DEVELOPMENT NO.:	24035929
APPLICANT:	Joel Callander
ADDRESS:	15 STURT ST GLENELG NORTH SA 5045
NATURE OF DEVELOPMENT:	Two level residential flat building comprising 2 dwellings
ZONING INFORMATION:	<p>Zones:</p> <ul style="list-style-type: none"> • Established Neighbourhood <p>Overlays:</p> <ul style="list-style-type: none"> • Aircraft Noise Exposure • Airport Building Heights (Regulated) • Affordable Housing • Building Near Airfields • Character Area • Prescribed Wells Area • Regulated and Significant Tree • Stormwater Management • Traffic Generating Development • Urban Tree Canopy <p>Technical Numeric Variations (TNVs):</p> <ul style="list-style-type: none"> • Minimum Frontage (Minimum frontage for a detached dwelling is 11m; semi-detached dwelling is 11m; row dwelling is 8m) • Minimum Site Area (Minimum site area for a detached dwelling is 350 sqm; semi-detached dwelling is 300 sqm; row dwelling is 250 sqm) • Maximum Building Height (Levels) (Maximum building height is 1 level)

ATTACHMENT A: Compromise Plan and Planning Report

The compromise proposal is set out in the letter from MasterPlan dated 1 July 2025 and the accompanying plans. These amended plans comprise an increased

Existing Dwelling

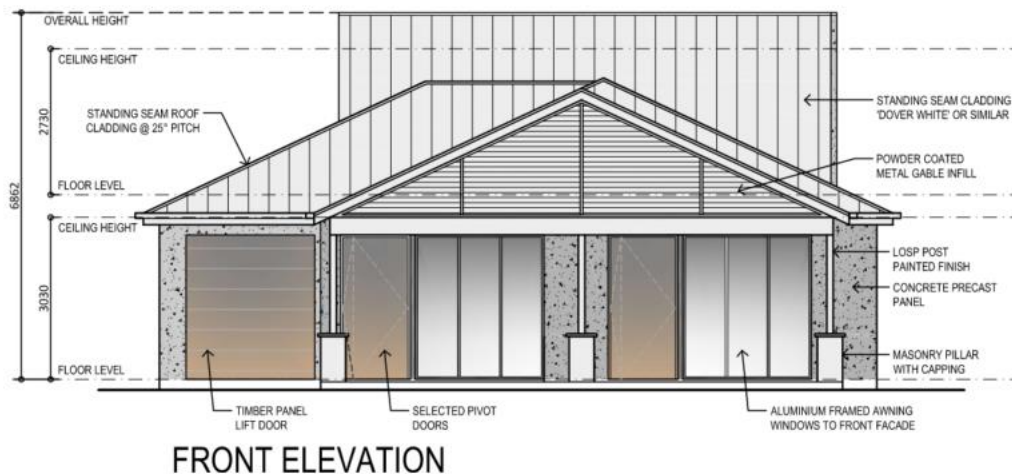
- *The form of the upper level building visible from the street is not consistent with the valued streetscape and character of the area.*
- *Building height is not consistent with the prevailing height of the character area.*
- *Architectural detailing, in particular the second level and front verandah, is not consistent with the prevailing character.*
- *The proposed building does not respond to the attributes expressed in the Character Area Statement HoBC5, in particular, the dominant verandah is not consistent with the mid-Victorian era as it is in Bungalow styling.*

Compromise Front Elevation

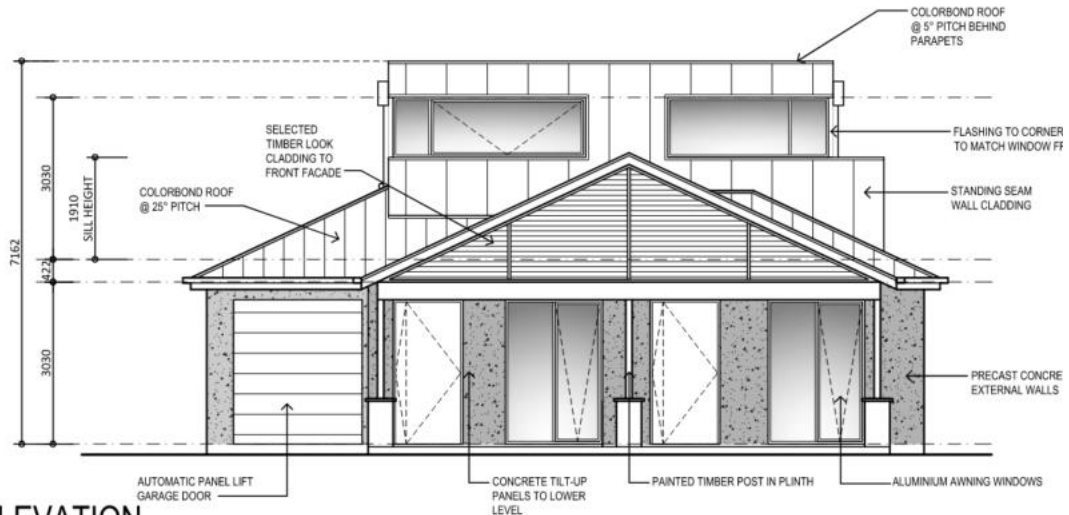
The compromise plans seek to address this by way of decreasing the building height by 300mm, from 7.1 metres to 6.8 metres. The roof of the ground level component has also been adjusted to obscure the eastern front vertical wall of the upper level. The upper level component has also been set-back a further 2.9 metres from the front verandah, and the street facing windows removed, which reduces its overall visual impact as viewed from the street.

The upper level component has been set-back a further 2.9 metres, from the front verandah, which contributes to the reduction in its visibility and overall visual impact as viewed from the street. The cladding of the upper level wall has been altered to comprise a standing seam cladding, painted dover white, which will match the ground level roof and contrast with the concrete precast panel ground level walls. Windows have also been removed, to contribute to blending in with the ground level roof.

The front verandah has been reduced in height and scale, but retains a similar form to that of the refused plans. Further assessment is also provided of the Character Area Statement, referencing the existing bungalow being replaced and others in the locality, being an inter-war dwelling style that is expressly contemplated in the Character Area.
